UNIVERSITY OF DELAWARE
NEWARK, DELAWARE
19716

Re: License No. 07-01579-19
Docket No. 030-10925

The University of Delaware requests an amendment to the referenced license regarding the following listed items:

PU-BE, I-CI, Storage
DISPOSAL VIA DECAY-IN-STORAGE
004-004A WOLF HALL

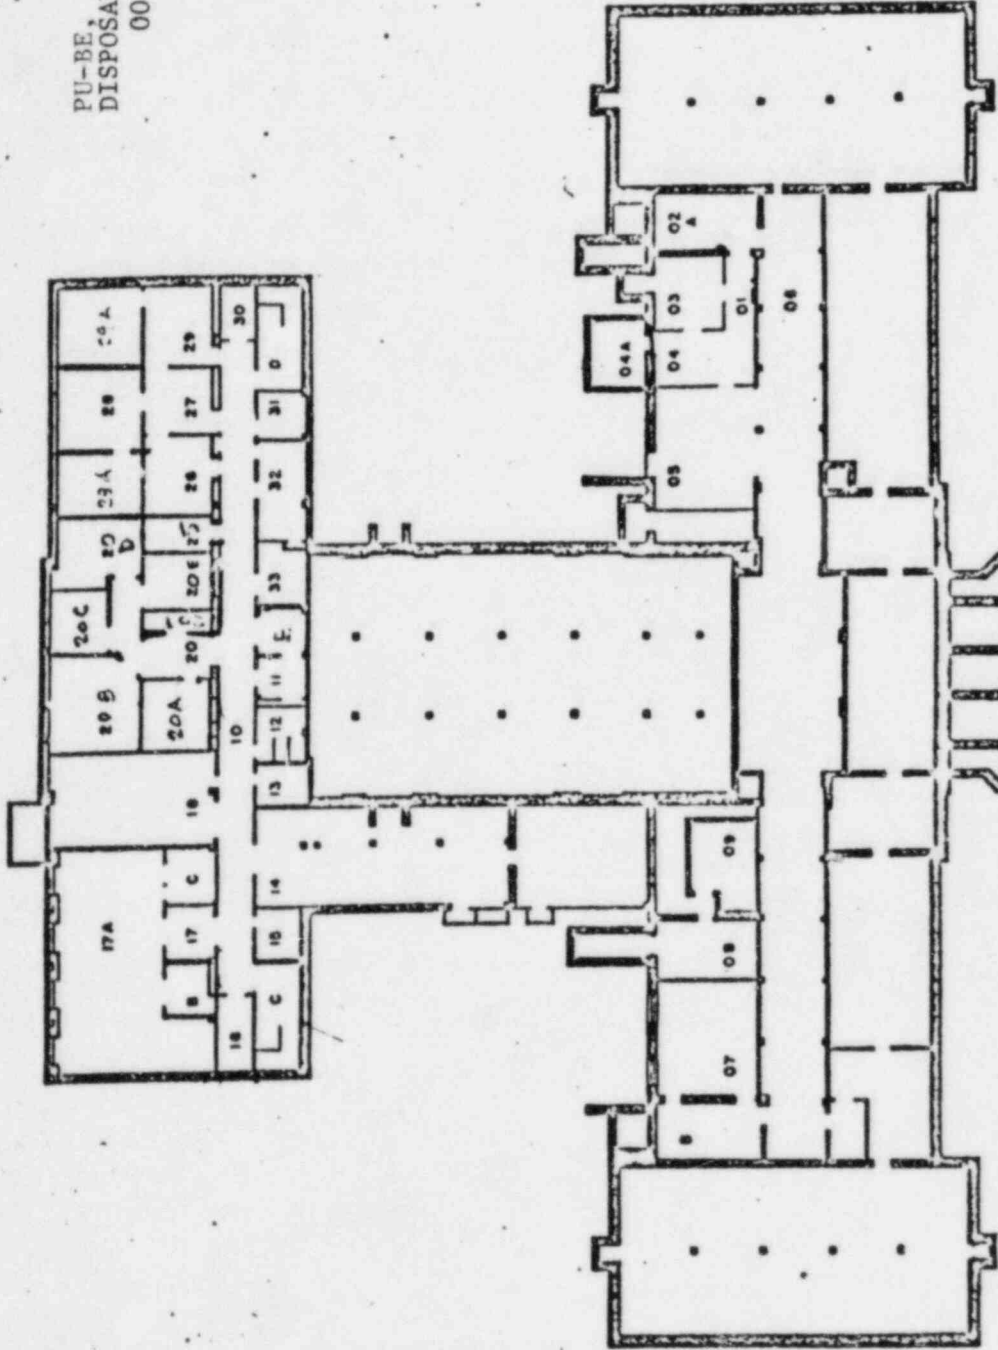
- Item 1.
Suggest license item 6.E. be amended to read Plutonium-239 to identify the atomic mass.
- Item 2.
Due to building renovations and changes in room assignments the Monsanto Research Corporation Pu-Be neutron source, no. M233, approximately 16 grams Pu-239, has been relocated from room 241 DuPont Hall to room 004A Wolf Hall. Room 004A Wolf Hall is the decay-in-storage waste facility. Radiation levels are background (0.02 mr/hr) in adjacent unrestricted areas. A diagram is attached.
